Access Compliance Report

Public Rights-of-Way

(Curb Ramps)

Intersection ID: 54321	Main Street: BELMONT_MANSION_DR	Cross Street: WRIGLEY_MANSION_DR	Location: NE
ADA ID: 75B99F430C9C	Ramp Type: Perp	Initial Pass/Fail: Fail	Overall Compliance: No
Severity Score: 12.5			
Codes/Mitigation Info/Possible Solution		Field Measurements/Component Compliance

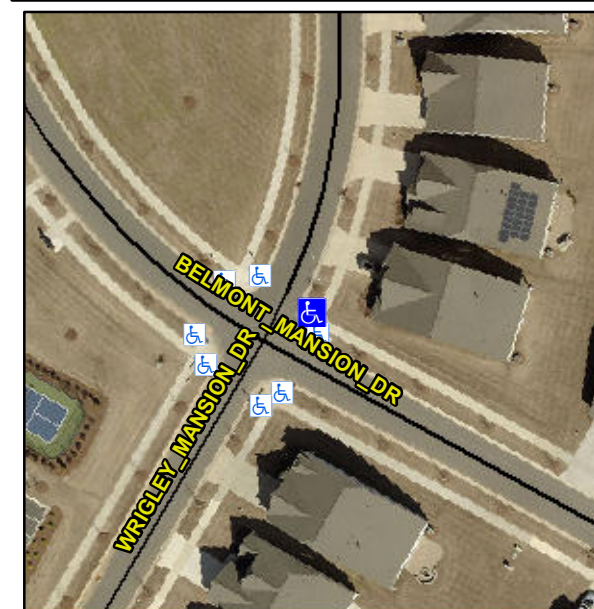
R304.5.3

Compliance	Description	Data	Compliance	Description	Data
N/A	Ramp Length (in)	101.0	Yes	Ramp Slope (%)	5.1
Yes	Ramp Width (in)	48.0	No	Ramp XSlope (%)	5.3
N/A	Flare Type LT	N/A	N/A	Flare Type RT	N/A
N/A	Flare Slope LT (%)	N/A	N/A	Flare Slope RT (%)	N/A
N/A	Flare Traversable LT?	N/A	N/A	Flare Traversable RT?	N/A
N/A	Landing Length (in)	N/A	N/A	DWS Provided?	N/A
N/A	Landing Width (in)	N/A	N/A	DWS Contrast?	N/A
N/A	Landing Slope (%)	N/A	N/A	DWS Length (in)	N/A
N/A	Landing X Slope (%)	N/A	N/A	DWS Full Width?	N/A
N/A	Landing Curb? (Y/N)	N/A	N/A	DWS Offset (in)	N/A
N/A	Shared Landing?	N/A			
N/A	Gutter Ponding?	N/A	N/A	Gutter Slope (%)	N/A
N/A	Gutter Lip Ht (in)	N/A	N/A	Gutter X Slope (%)	N/A
N/A	Painted X Walk1?	No	N/A	Painted X Walk2?	N/A
	X Walk 1 Direction	To NW		X Walk 2 Direction	N/A
N/A	X Walk 1 Width (in)	N/A	N/A	X Walk 2 Width (in)	N/A
	X Walk 1 Slope (%)	4.0		X Walk 2 Slope (%)	N/A
	X Walk 1 X Slope (%)	4.6		X Walk 2 X Slope (%)	N/A

Remove & Replace Entire Ramp.
